DATE: December 16, 2019

SUBJECT: ADDENDUM #4 TO THE BIDDING DOCUMENTS FOR:  
**BID GROUP #8**  
**MASTER FACILITY PLAN IMPLEMENTATION**  
**COMMUNITY HIGH SCHOOL DISTRICT 99**  
**1436 NORFOLK STREET**  
**DOWNERS GROVE, IL 60516**

This addendum forms a part of the Bidding Contract Documents, dated November 20, 2019. Bidders must acknowledge receipt of this Addendum in the space provided on the Bid Form. Drawing revisions clouded and tagged throughout with delta 41.

Project Number:  
5274-42  
Drawn By:  
J.G.  
Sheet:

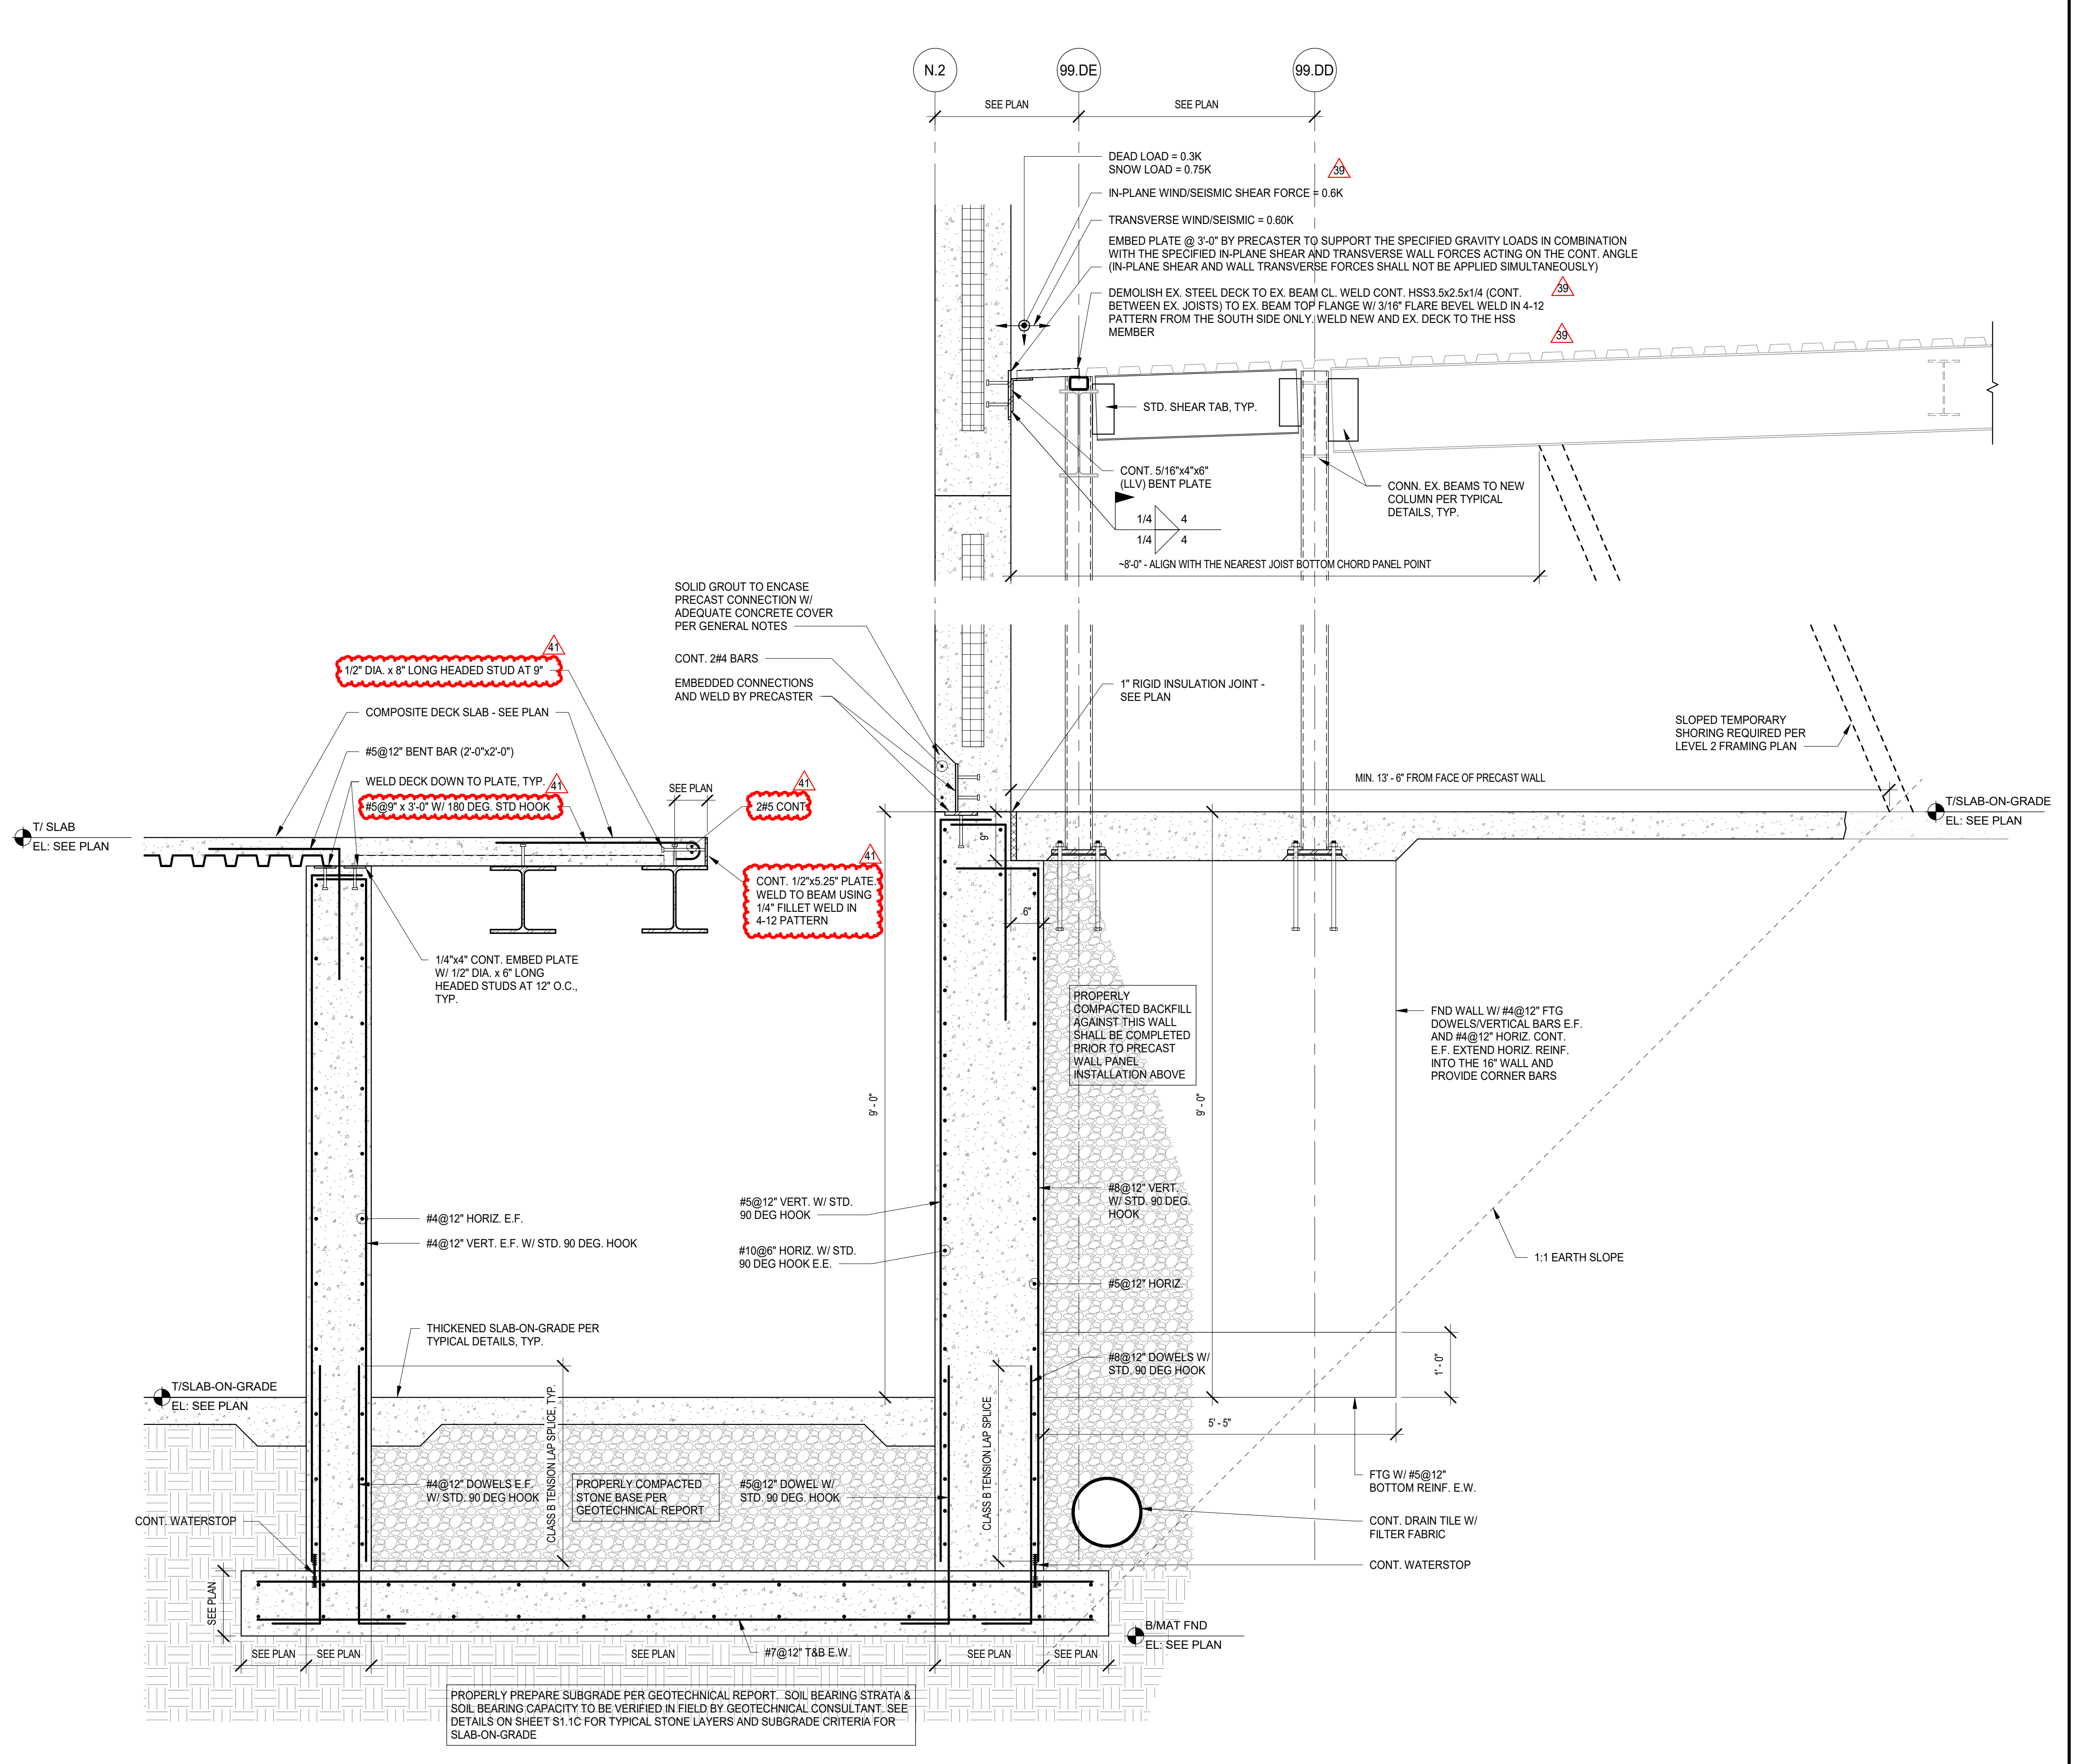
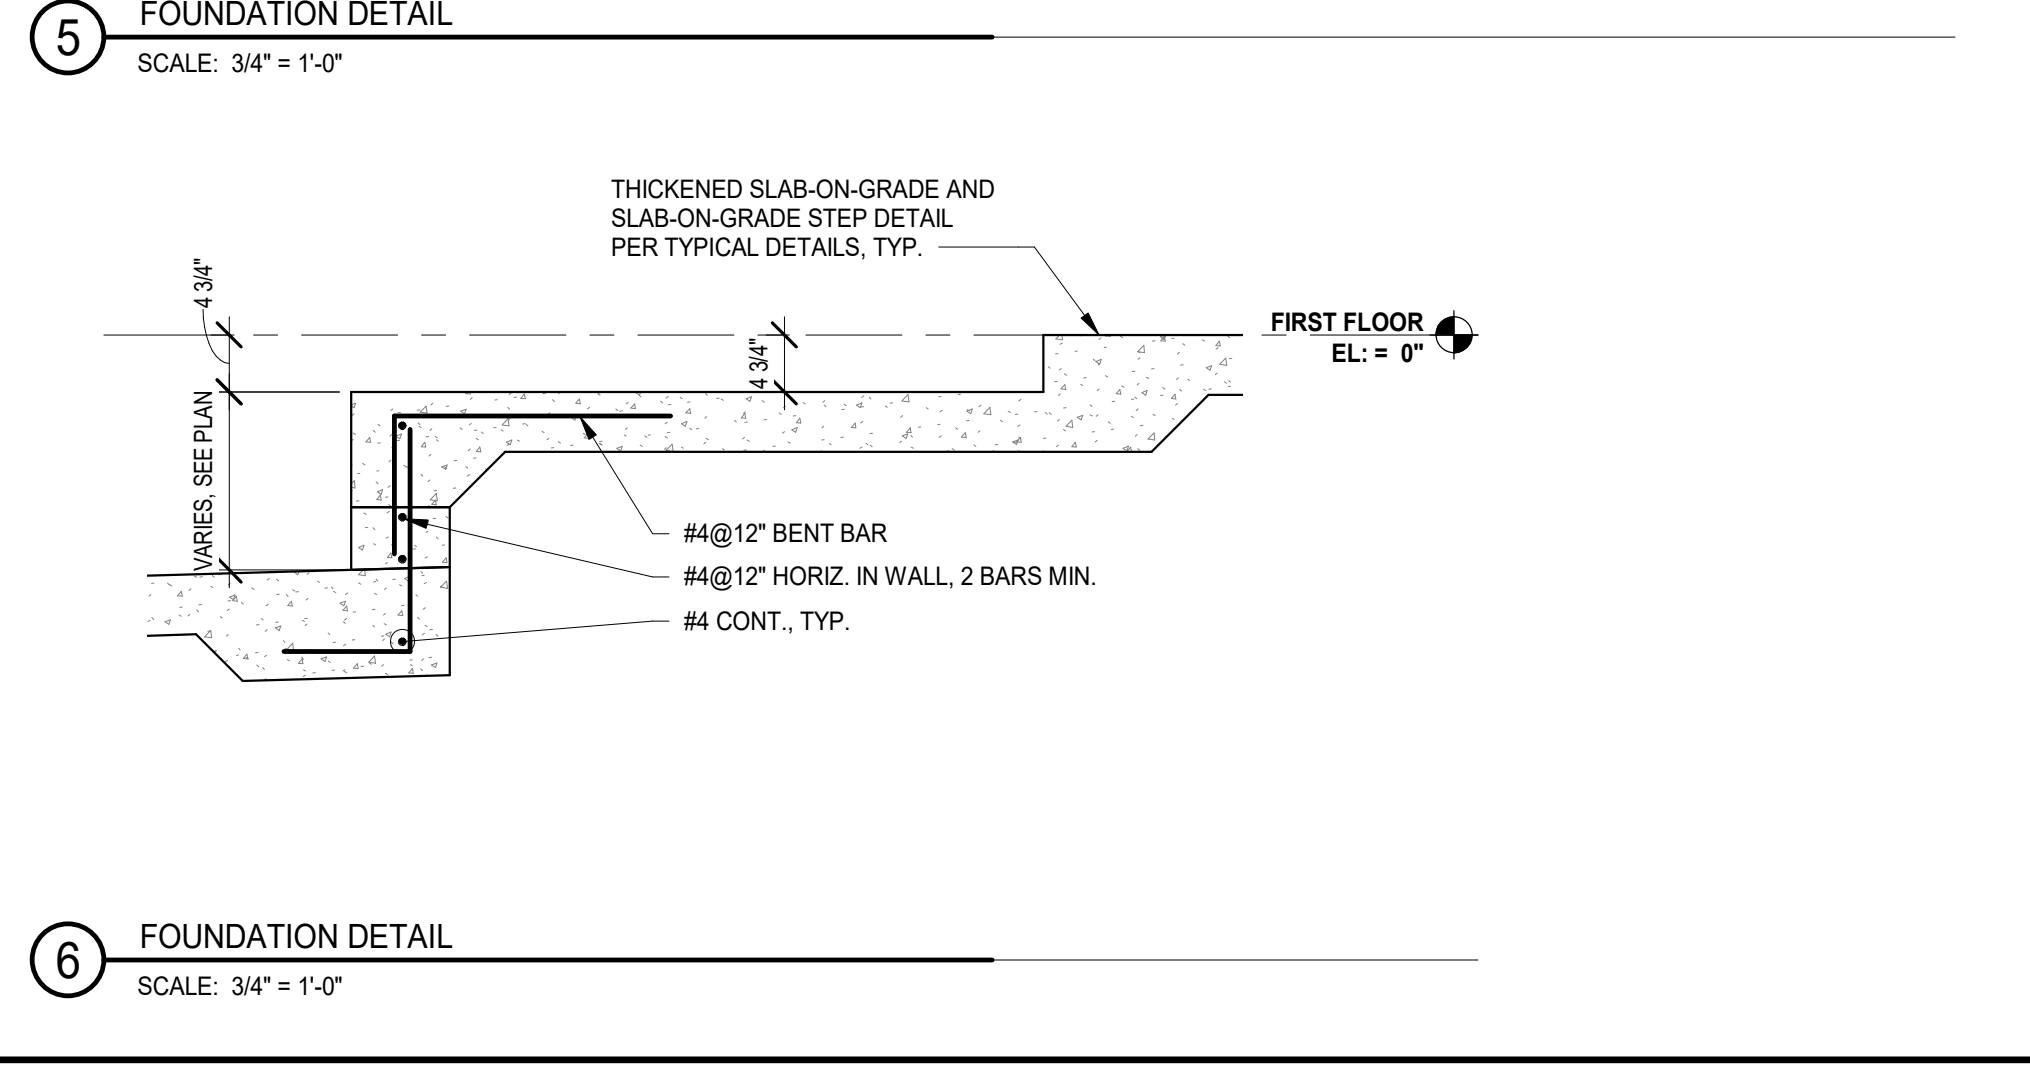
11. Sheet S2.7C-F ENLARGED PLANS (**Full size sheet issued**)
  - a. Plan 2: Added steel support for the spiral stair and revised existing framing and beam end reactions at precast wall supports accordingly.
